New York State Department of Environmental Conservation  
-----

FINGER LAKES LPG STORAGE, LLC

Application Number  
8-4432-00085

**GAS FREE SENECA'S SUR-REPLY BRIEF**

**Figure 3: Cavern 58 Roof Collapse History**  
(Annotated Excerpt from Cross-Section AA')

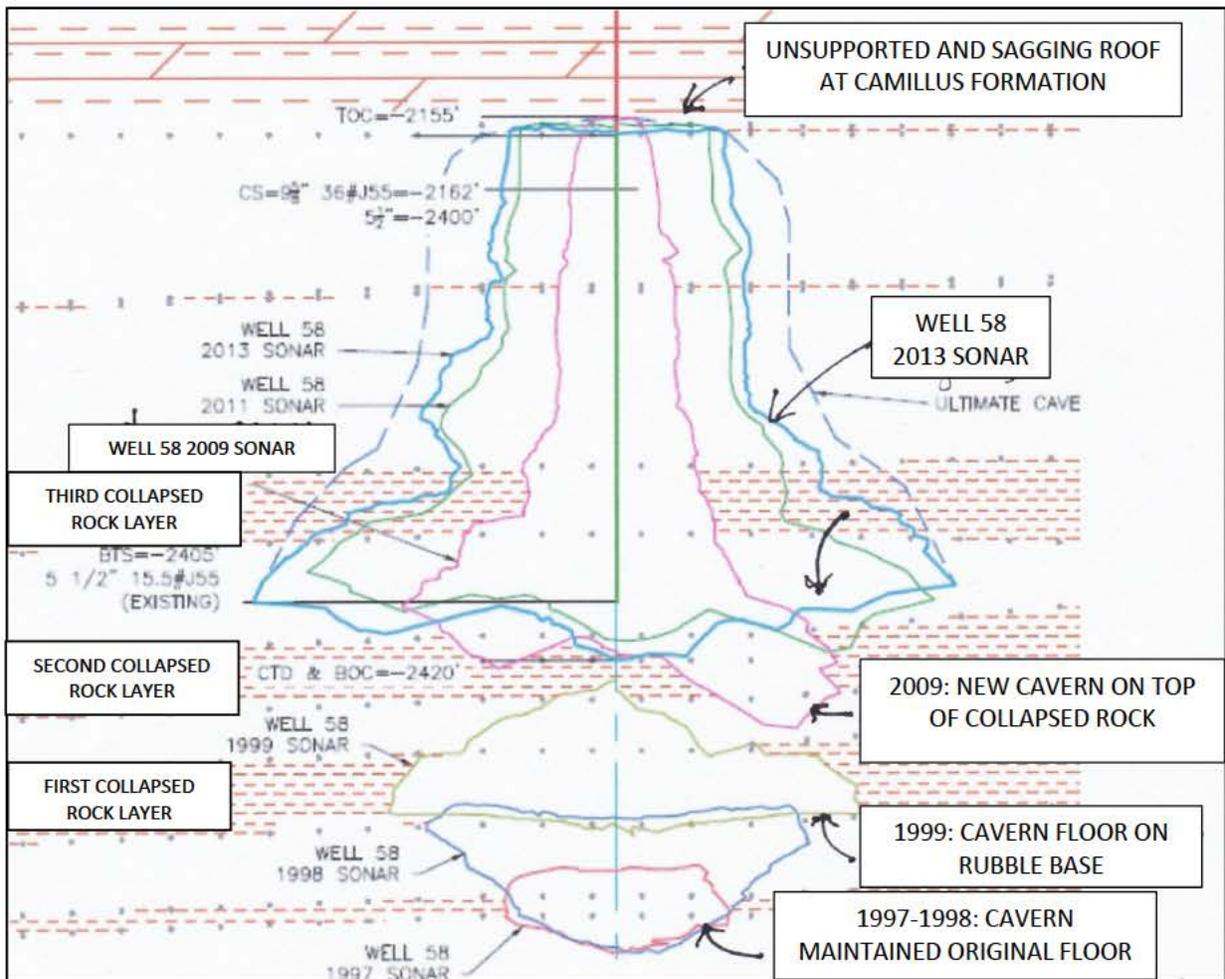
[REDACTED] there is abundant record evidence that rock fell suddenly and repeatedly from its walls and ceiling. As can be seen in Figure 3 on the following page, the rock roof of the cavity shown in the 1998 sonar collapsed, with the top of the resulting

rubble pile forming the floor of the cavity shown in the 1999 sonar. See Clark Report, Ex. E (demonstrating DEC’s understanding that “the older cavity of October 1998 had been nearly filled with shale and salt rubble in the sho[r]t period between earlier sonar surveys”). Thereafter, the layer of rock that formed the ceiling of the cavern shown in the 1999 sonar also collapsed,

very likely producing the rubble that prevented Mr. Larry Sevenker from obtaining a sonar survey in 2001. A third layer of rock, which would have formed the roof of the cavern when solutioning began through the current tubing string, collapsed to permit salt dissolution all the

way to the Camillus formation as early as 2009. No other explanation accounts for the rubble-filled portion of the cavern, [REDACTED]

The documented, but nevertheless disputed, history of collapse in Cavern 58 raises questions about its long-term integrity, because its current roof has reached the Camillus formation, and the rock there already is sagging. Although the FLLPG caverns have been described as cavities in bedded salt, *see* Final DSEIS Text (Document List IV.A.1) at 148, Gallery 2 extends upward beyond the salt, and whether the unsupported Camillus formation safely can serve as the new roof and part of the cavern walls, when the current roof yields to the force of gravity, is a disputed question of fact.<sup>8</sup> *Id.* [REDACTED]
